December 17, 2013

**SUBJECT: Transmittal of Responses to Ohio Environmental Protection Agency  
Comments on Comprehensive Legacy Management and Institutional  
Controls Plan, Revision 7, Draft**

**Responses to Ohio EPA Comments on  
Comprehensive Legacy Management and Institutional Control Plan  
Volumes I and II**

SSOD Location Map

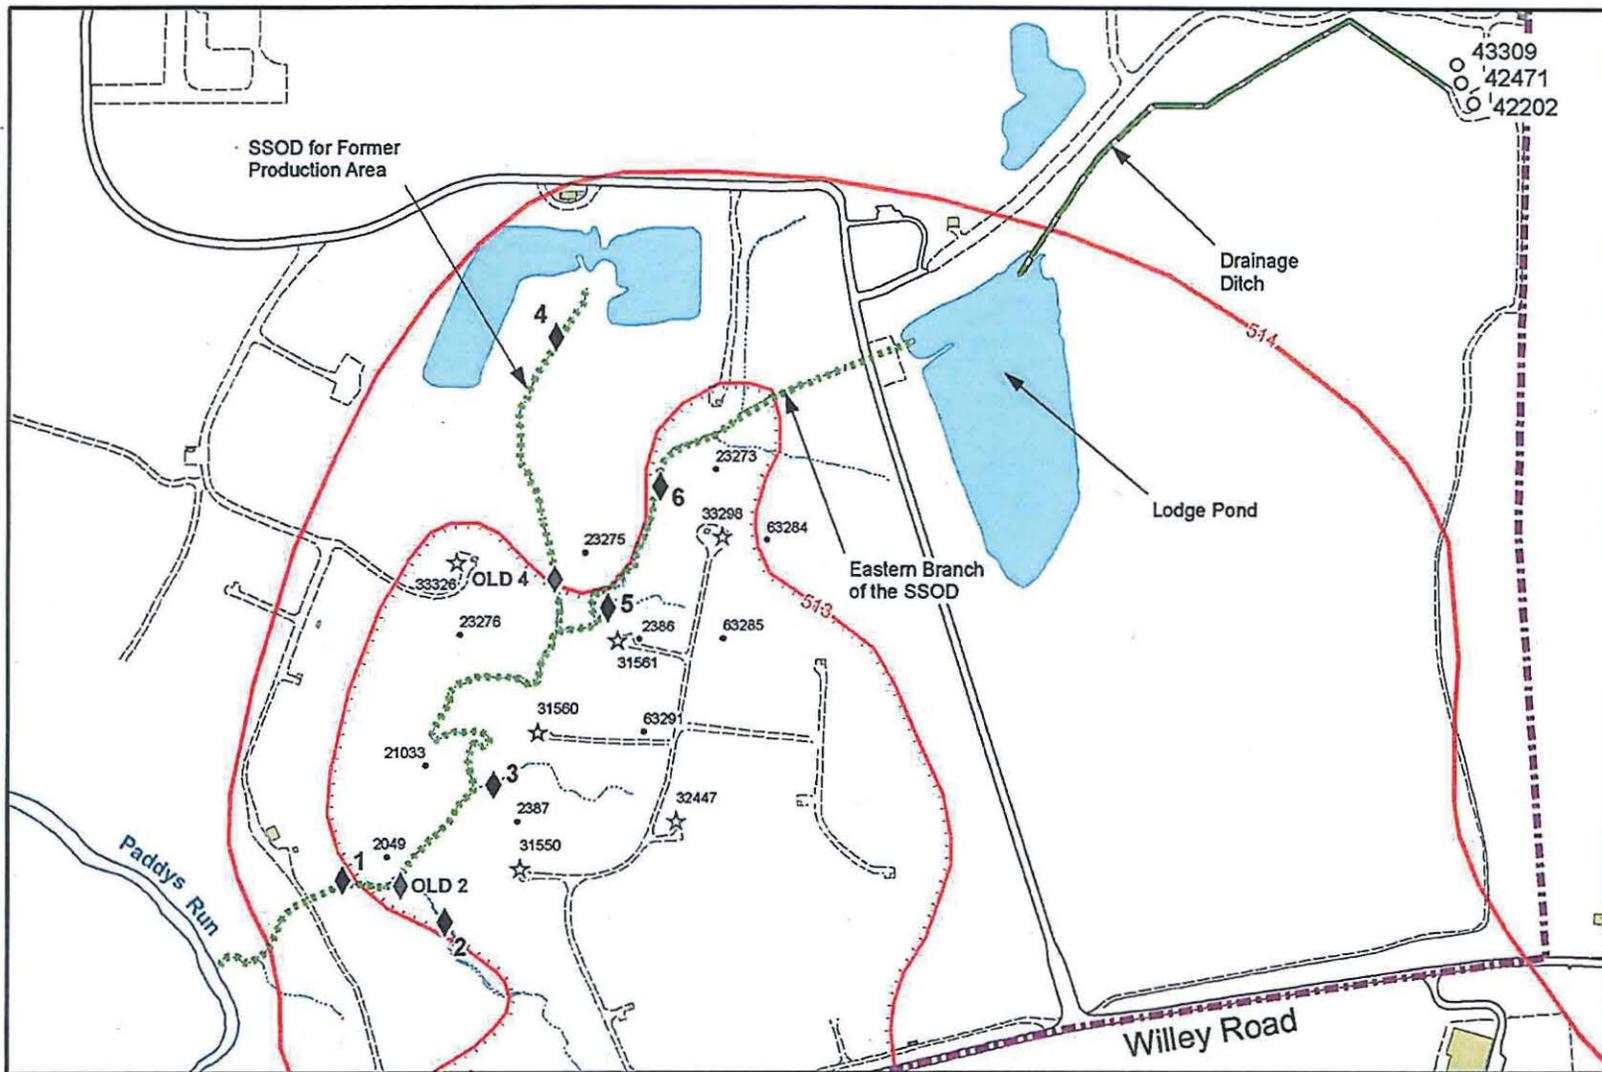
Comment: In response to Ohio EPA comment 5, additional justification for suspending pumping to the storm sewer outfall ditch (SSOD) is requested. In the case of monitoring wells located adjacent and immediately down gradient of the SSOD, a discussion of uranium trend should be provided, covering the period of supplemental pumping (2007-2012). An initial trend could provide indication of beneficial uranium soil desorption, resulting from enhanced infiltration. According to Table A.2-19 of the 2012 Site Environmental Report, an upward trend in excess of the FRL was observed in monitoring well 2387.

Response: Attached, is a location map for the SSOD that shows the SSOD in relation to the 4<sup>th</sup> quarter 2012 groundwater elevation contours. These elevation contours are the most recent groundwater elevation contours reported in the 2012 Site Environmental Report. It should be noted though that the water level surface shown in this figure is representative of the water level surface that was present between 2007 and 2012, due to pumping in the South Field extraction wells. As shown in the figure, most of the south field extraction wells are located east of the SSOD; groundwater infiltrating into the aquifer from the SSOD would migrate to the east. The SSOD erodes through the glacial till just south of where Flume 6 was located; therefore, the potential for infiltration into the aquifer also begins just south of the former location of Flume 6.

Soil and sediment in the SSOD was certified clean prior 2007. The objective of the infiltration activity was to flush the dissolved uranium plume located beneath the SSOD. As shown in the attached figure, South Field extraction wells are located just east of the SSOD. The ground surface between the extraction wells and the SSOD is too steep to allow for the installation of monitoring wells. Therefore, the closest monitoring wells east of the SSOD are in line for the most part with the extraction wells and are under heavy influence from the extraction wells.
